# Access Compliance Report

## Public Rights-of-Way

### (Curb Ramps)

| Intersection ID: 49383 | Main Street: CORRIENTE_CT | Cross Street: SOUTH_DEVON_ST | Location: S            |

| ADA ID: DBCEC44AE418   | Ramp Type: PerpDiag       | Initial Pass/Fail: Fail      | Overall Compliance: No |

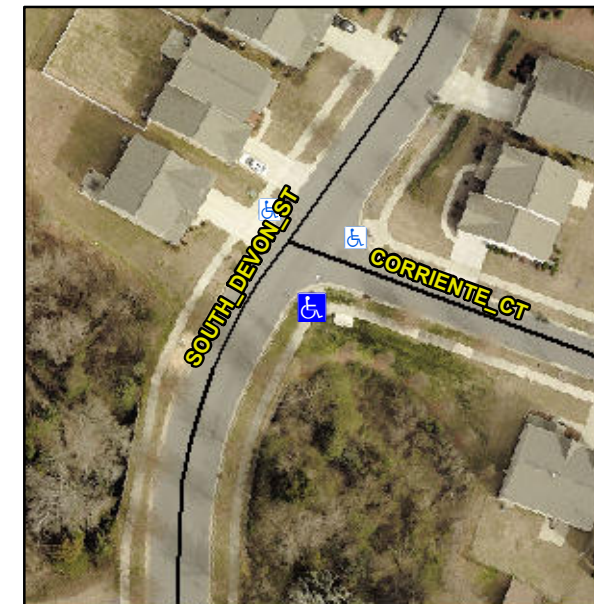
**Not Found, R304.5.1, R304.5.3**

| Compliance | Description           | Data  | Compliance | Description                 | Data  |
|------------|-----------------------|-------|------------|-----------------------------|-------|
| No         | Ramp Width (in)       | 45.5  | No         | Ramp XSlope (%)             | 2.3   |

**Remove & Replace Curb Ramp With Two New Directional Ramps or Equivalent.**
